<b>AMENDMENT OF SOLICITATION/MODIFICATION OF CONTRACT</b>			1. Contract Number	Page of Pages 1   1
2. Amendment/Modification Number DCAM-2008-B-0014-001	3. Effective Date 11/14/2007	4. Requisition/Purchase Request No.	5. Solicitation Caption Eastern Market Rehabilitation

**ADDENDA NO. 1****EASTERN MARKET REHABILITATION**

IFB No. DCAM-2008-B-0014  
 225 7<sup>th</sup> Street SE  
 Washington, DC

**THE DOCUMENTS DATED 19 SEPTEMBER 2007 SHALL BE AMENDED AS FOLLOWS:**

PROJECT NO. EA710B  
BLDG ID NO. 47  
DATE: 14 NOV 2007  
DRAWING NUMBER  
F1, D10/M401

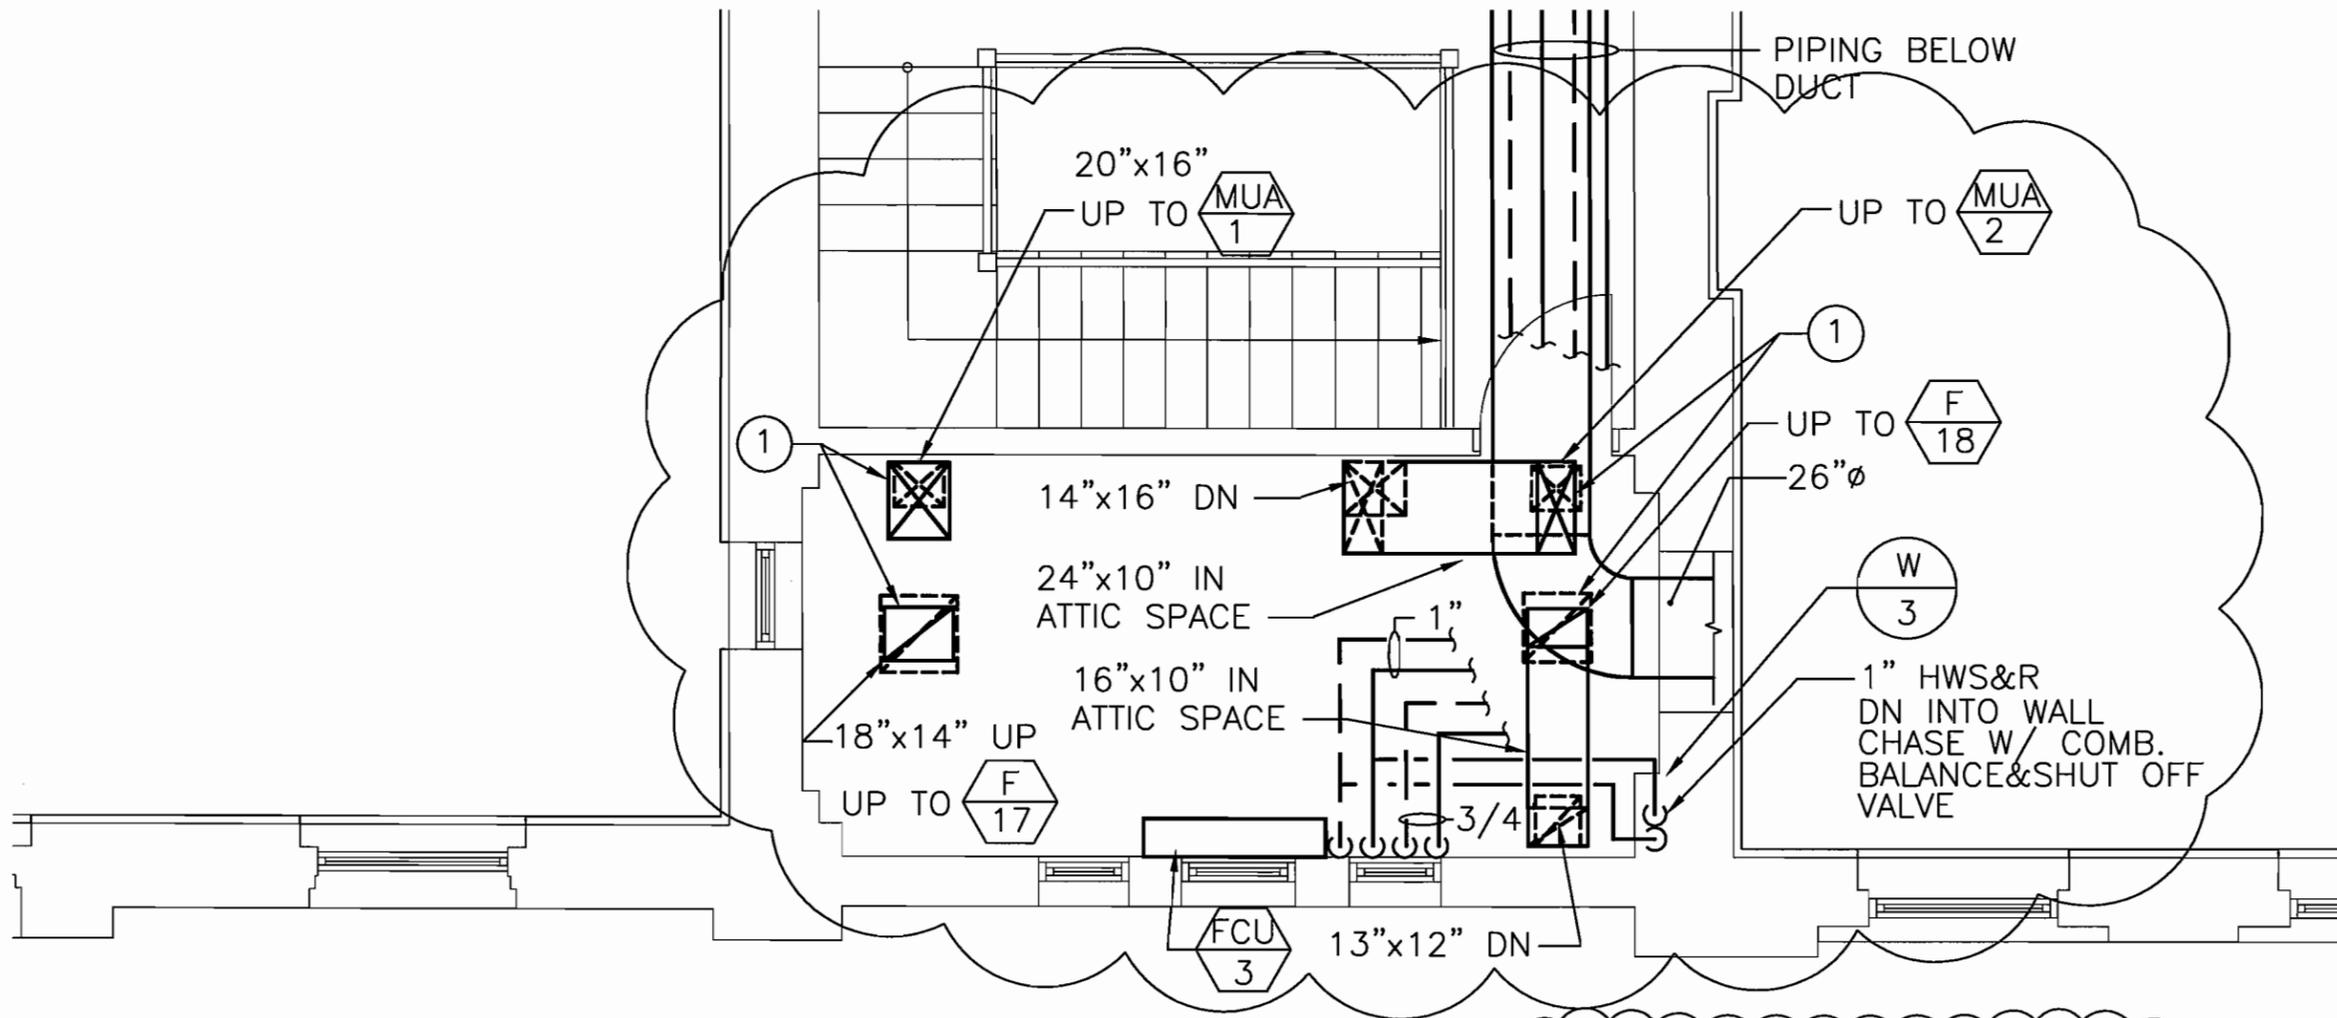
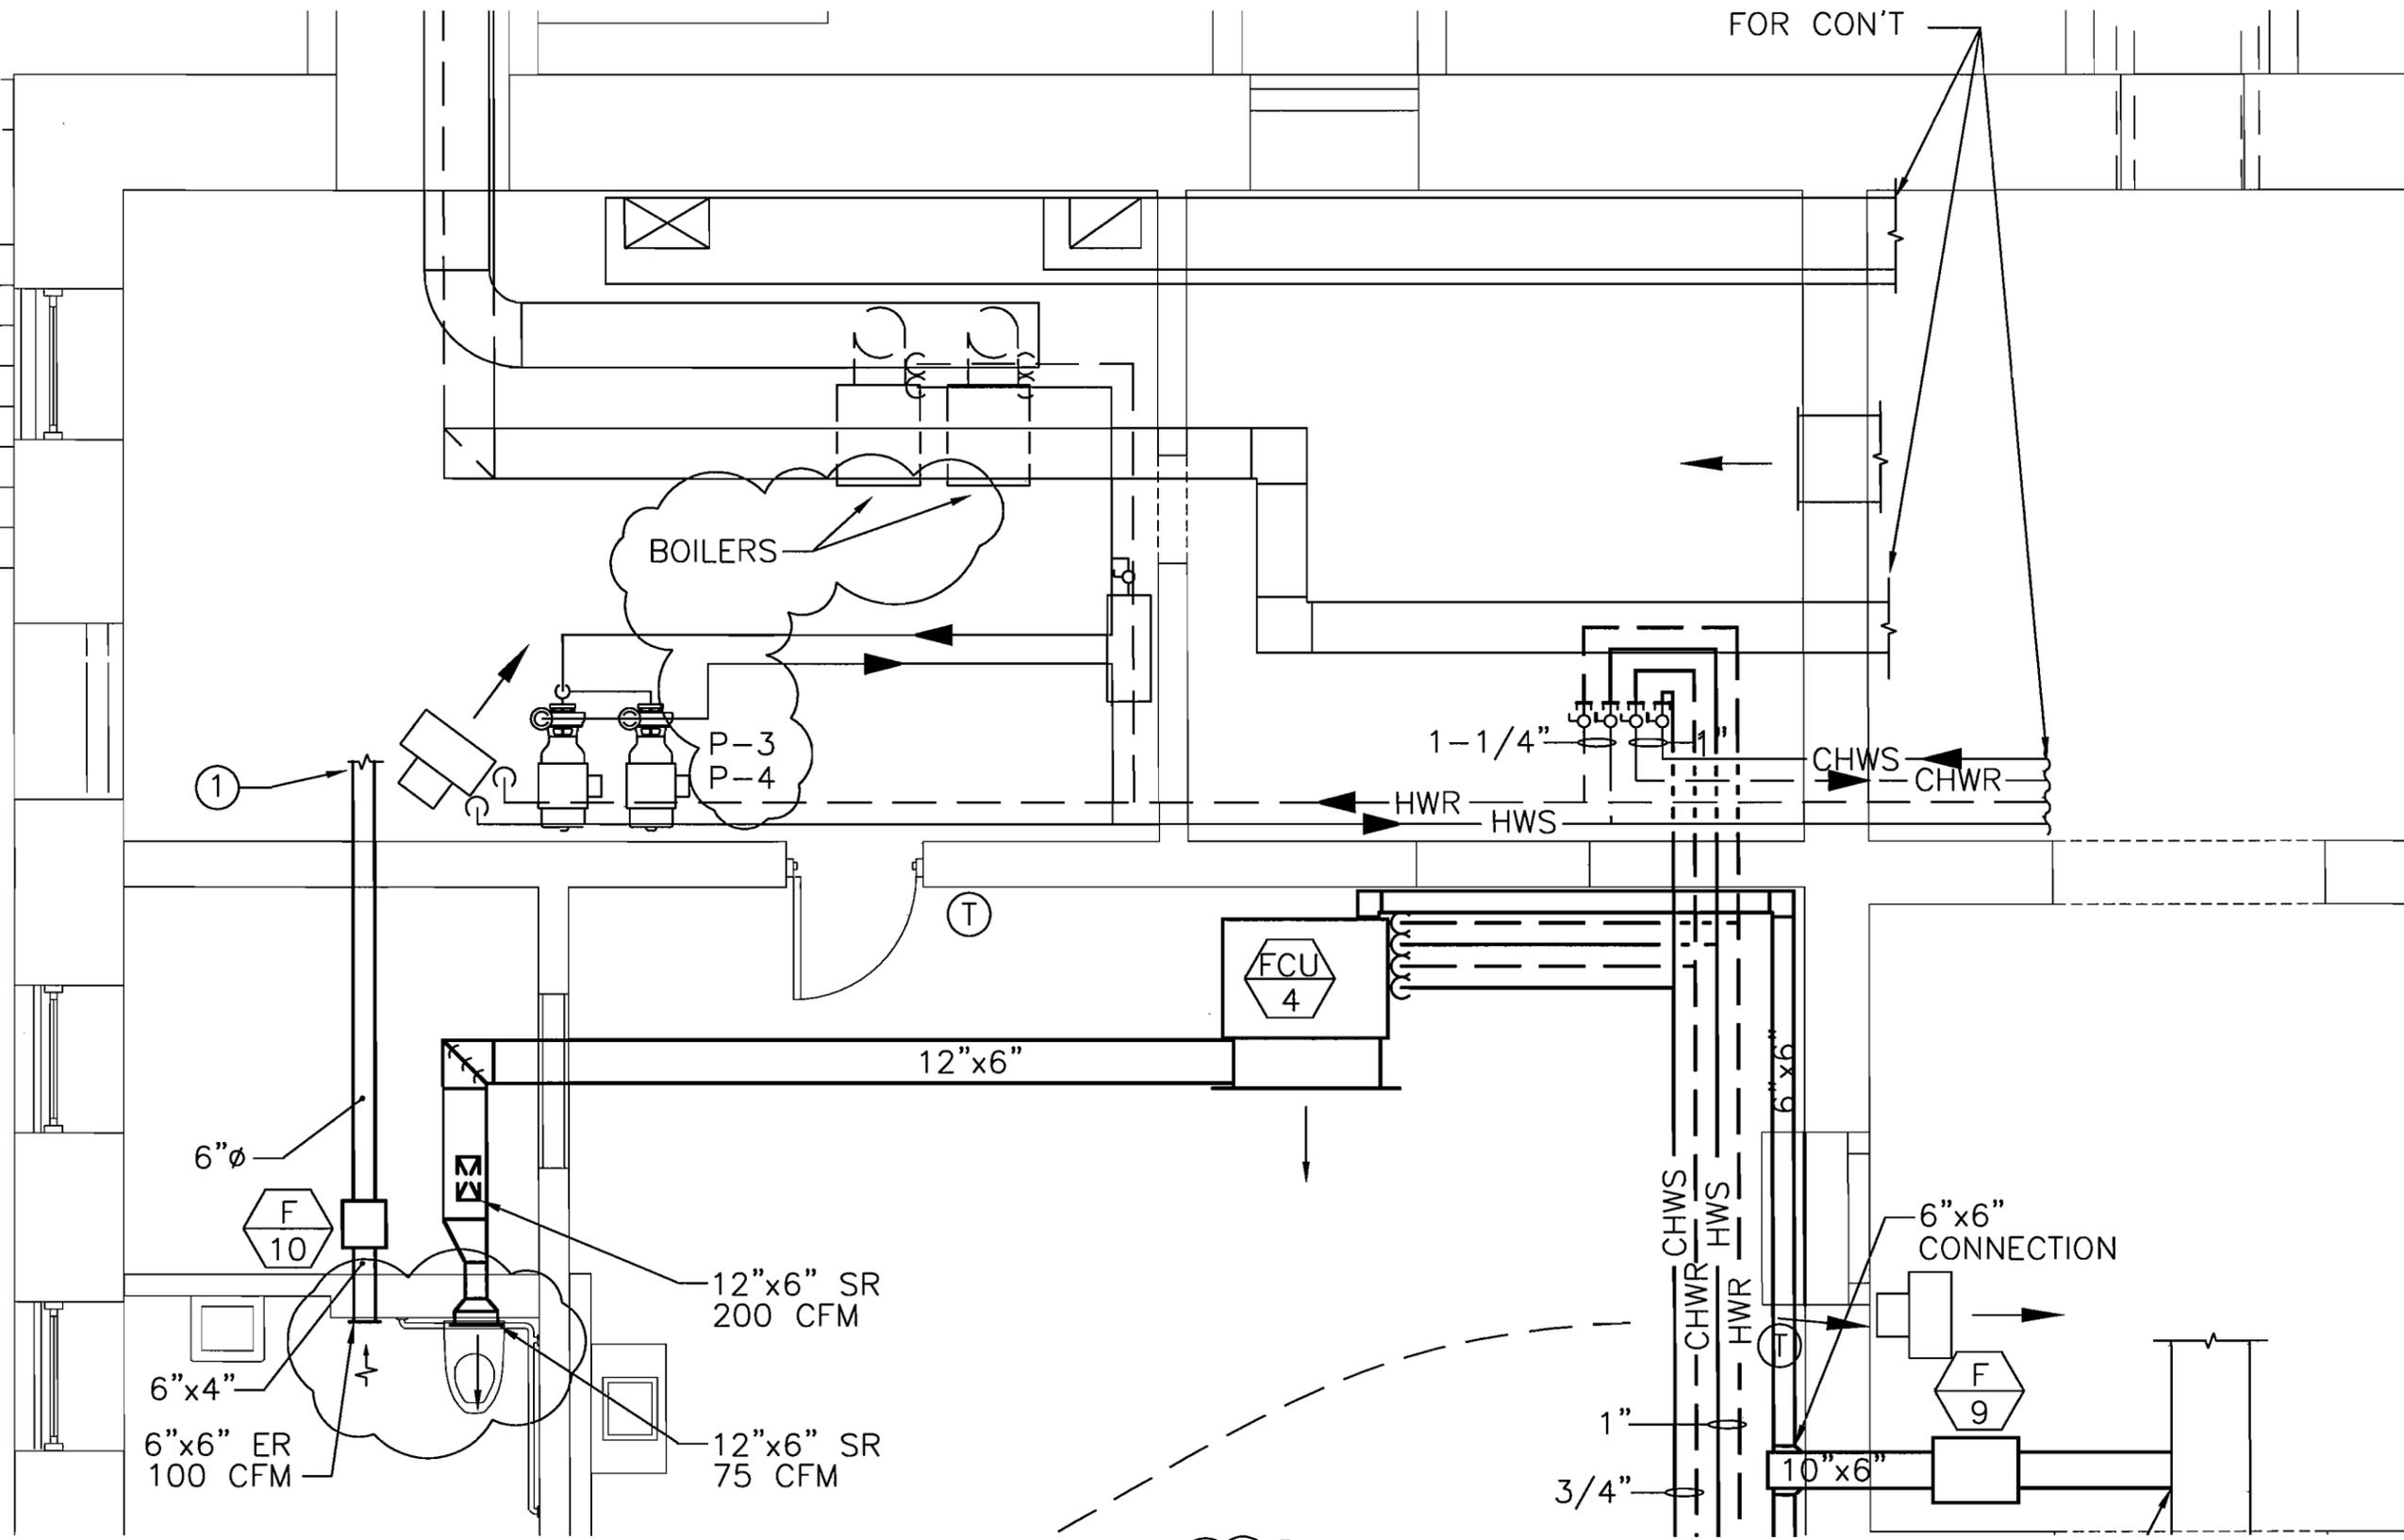
Sheet No.	Change:
M401	<p><u>Revise</u> drawing M401 as described below and <b>as indicated on the attached detail, F1,D10/M401, dated 14 Nov 2007.</b></p> <ol style="list-style-type: none"> <li>1. <u>Revise</u> drawing F1 to modify the boiler flue dimension to 16 inch diameter.</li> <li>2. <u>Revise</u> drawing D10 at grid location F13 to modify the ductwork layout associated with exhaust fans F-18 and F-17 and make up air units MUA-1 and MUA-2.</li> <li>3. <u>Revise</u> drawing D10 at grid location N13 to revise the exhaust fan associated with ductwork to F-8.</li> </ol>
M402	<p><u>Revise</u> drawing E1 to clarify the airflow direction at the toilet room exhaust register and supply register and to identify the boilers and pumps, <b>as indicated on the attached detail, E1/M402, dated 14 Nov 2007.</b></p>
M502	<p><u>Revise</u> drawing M502 as described below and <b>as indicated on the attached detail, A1, M11/M502, dated 14 Nov 2007.</b></p> <ol style="list-style-type: none"> <li>1. <u>Revise</u> A1 "Gas Riser Diagram" to clarify the gas service connection at the boilers.</li> <li>2. <u>Add</u> to drawing A1 "Gas Notes: <ol style="list-style-type: none"> <li>1. Gas service sizing based on low pressure gas service (0.5 PSIG or less) with a pressure drop of 0.3" WC.</li> <li>2. Max. developed length is 50'."</li> </ol> </li> <li>3. <u>Revise</u> drawing M11 titleblock "PRV Fan Detail" to read "Sidewall Propeller Fan Detail".</li> </ol>

GROTHEER & COMPANY 1612 K STREET NW, SUITE LL-3 WASHINGTON, DC 20006 (202) 223-5752	EASTERN MARKET REHABILITATION DC OFFICE OF PROPERTY MANAGEMENT WASHINGTON, DC	PROJECT NO. EA710B BLDG ID NO. 47 DATE: 14 NOV 2007 DRAWING NUMBER A1,M11/M502
SCALE: NO SCALE	ADDENDUM NO. 1 GAS RISER DIAGRAMS

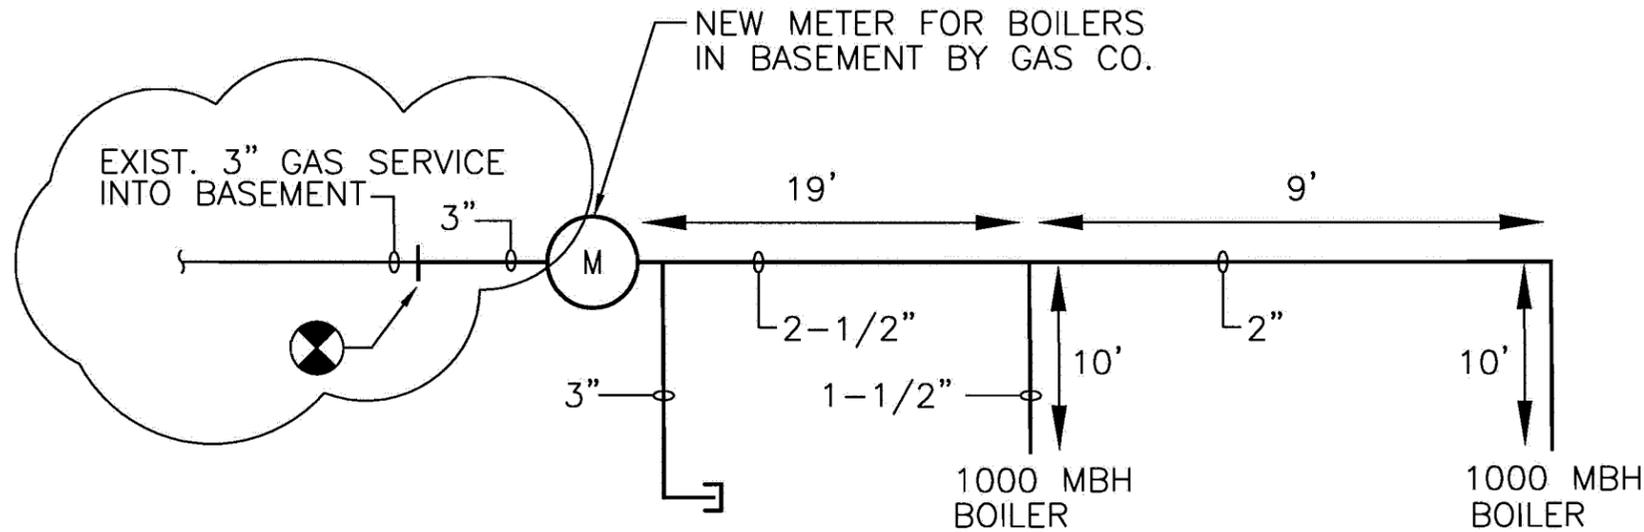
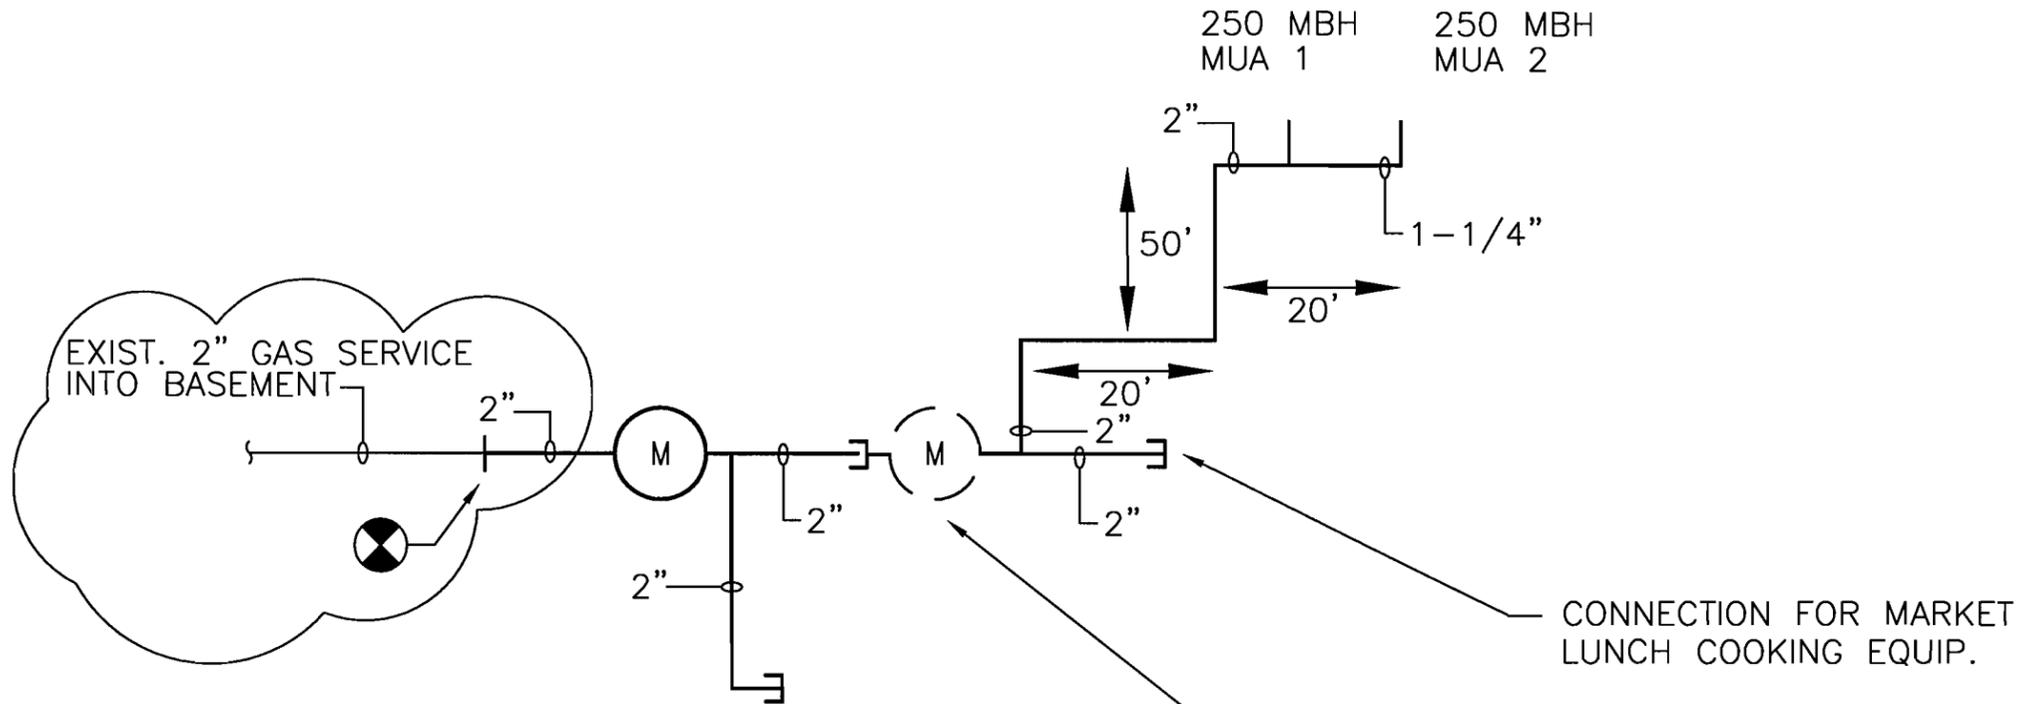
M502	<p><u>Revise</u> drawing M502 as described below and <b>as indicated on the attached detail, A1, M11/M502, dated 14 Nov 2007.</b></p> <ol style="list-style-type: none"> <li>1. <u>Revise</u> drawing A1 "Gas Riser Diagram" to clarify the gas service connection at Market Lunch vendor stall.</li> <li>2. <u>Add</u> to drawing A1 "Gas Notes: <ol style="list-style-type: none"> <li>1. Gas service sizing based on low pressure gas service (0.5 PSIG or less) with a pressure drop of 0.3" WC.</li> <li>2. Max. developed length is 125'."</li> </ol> </li> </ol>
M601	<p><u>Revise</u> "Fan Schedule" title to read "Fan Schedule (Part 1)".</p> <p><u>Add</u> "Notes:</p> <ol style="list-style-type: none"> <li>1. See M602 for fan schedule associated with vendor equipment.</li> <li>2. See sequence of operation spec for fan operation." <p><u>Revise</u> "Fan Coil Unit Schedule" under column "Unit No." to read "FCU-1, FCU-2, FCU-3, FCU-4, and FCU-5".</p> <p><b>See attached detail, M601, dated 14 Nov 2007.</b></p> </li></ol>

CAPPED PIPE FOR FUTURE CONNECTION OF VENDOR EQUIPMENT BY OTHERS. COORDINATE INSTALLATION & METERING W/ GAS COMPANY

FUTURE MARKET LUNCH GAS METER. COORDINATE INSTALLATION & METERING W/ GAS COMPANY

GAS NOTES:  
 1. GAS SERVICE SIZING BASED ON LOW PRESSURE GAS SERVICE (0.5 PSIG OR LESS) WITH A PRESSURE DROP OF 0.3" WC.  
 2. MAX. DEVELOPED LENGTH IS 125'
